STAFF REPORT

RE: **1300 Atlantic Boulevard (C.B. Harvey Rest Beach Park)
(permit application # T17-8522)**

FROM: Karen DeMaria, City of Key West Urban Forestry Manager

Tree #2A:

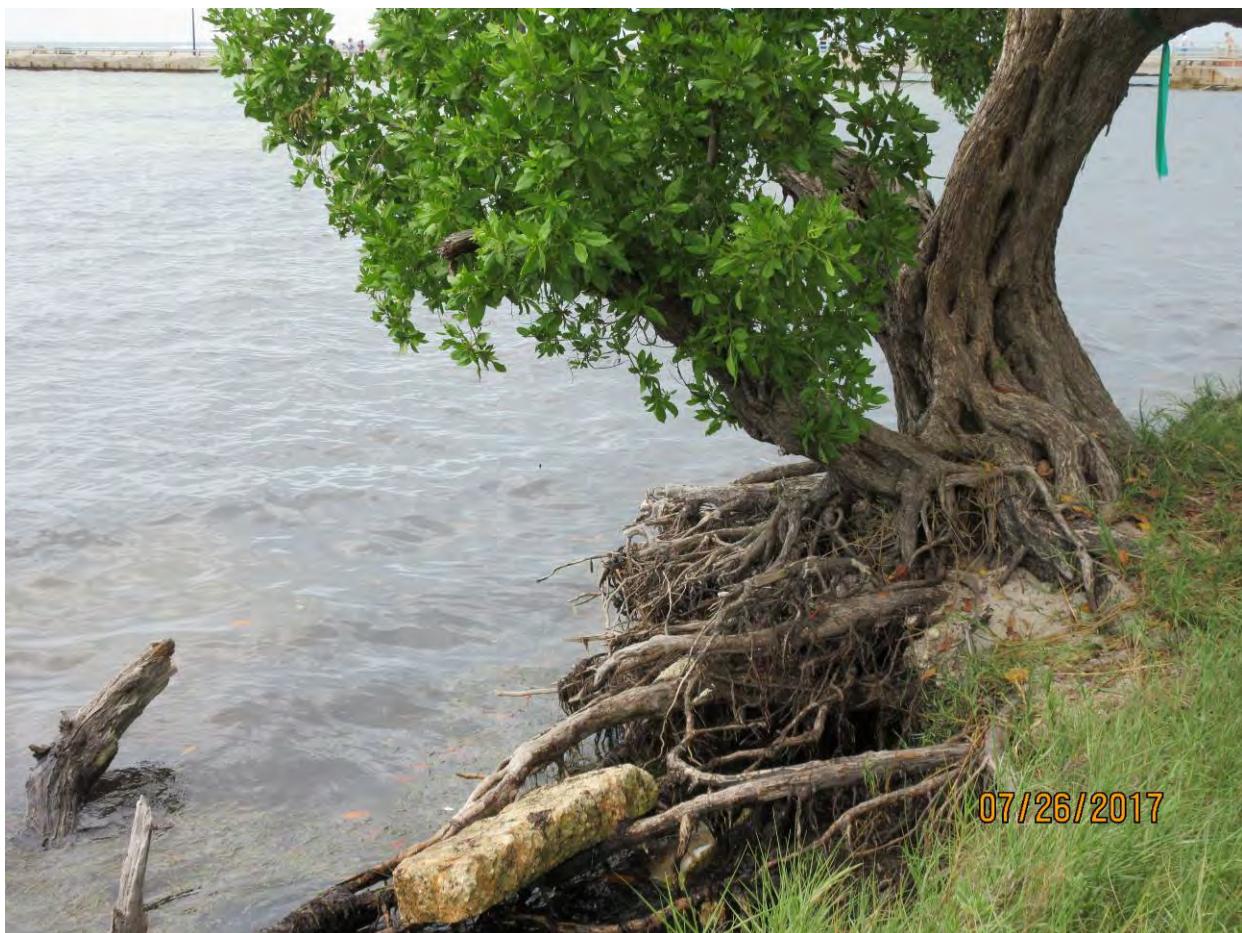
NOTE: It might be possible to do a heavy maintenance trim on this tree to remove one of the main branches. A final decision will be made once site is staged for work.

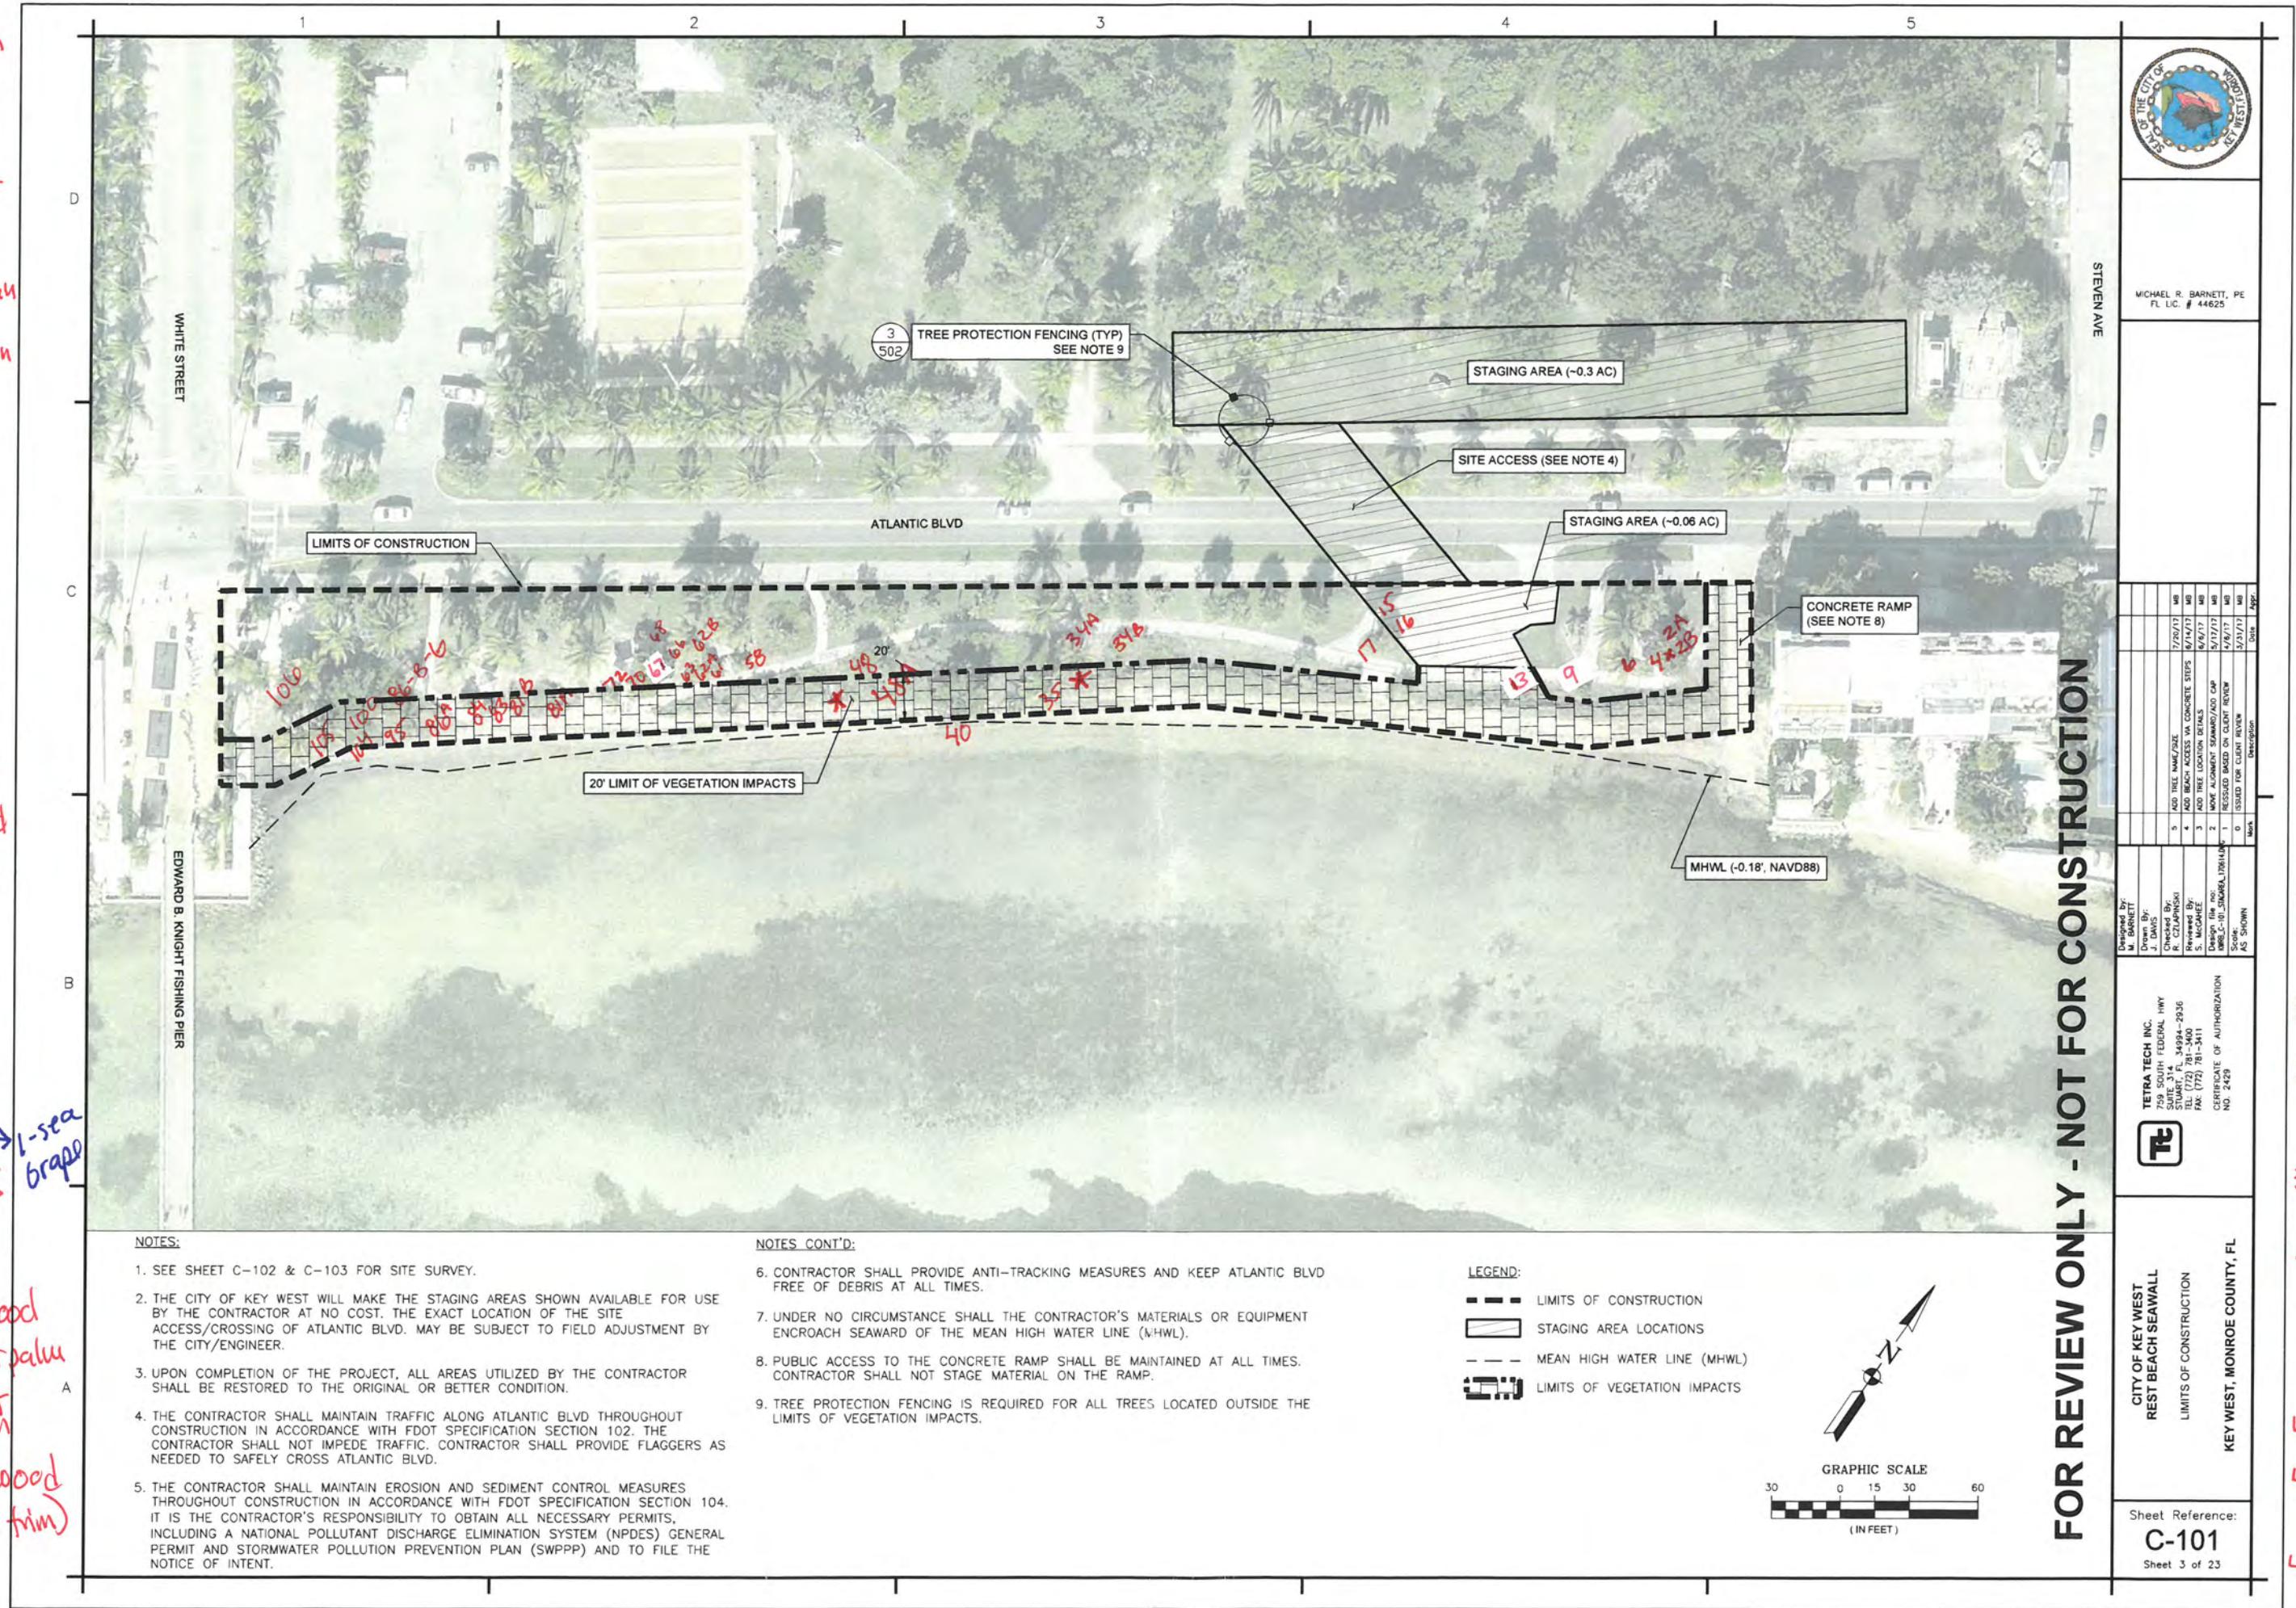
Two of the buttonwood trees appear to be on the edge of the proposed work area. It is hoped that these trees will only need to have some branches/trunks removed. It is not known at this time the likelihood of the survivability of transplanting a large buttonwood tree, the Jamaican Capers, or the Bay Cedar tree or the cost of such work. During the contract process through engineering, this information will be clarified.

The Contractor must work with the Engineering Department and the Urban Forester to specifically identify the work area in order to minimize impacts to the trees. No permits will be issued for the project until a specific tree removal/transplantation/maintenance trimming plan has been submitted to the Urban Forester.

Recommendation: **Recommend approval of the removal of (4) Buttonwoods, (3) Sea Grapes, (2) Jamaican Capers, (1) Seven Year Apple, and (1) Bay Cedar tree at 1300 Atlantic Boulevard, Rest Beach, to be replaced with a total of 145.6 caliper inches of dicot trees from the approved list, FL#1, to be planted on site, if all of the trees are removed.**
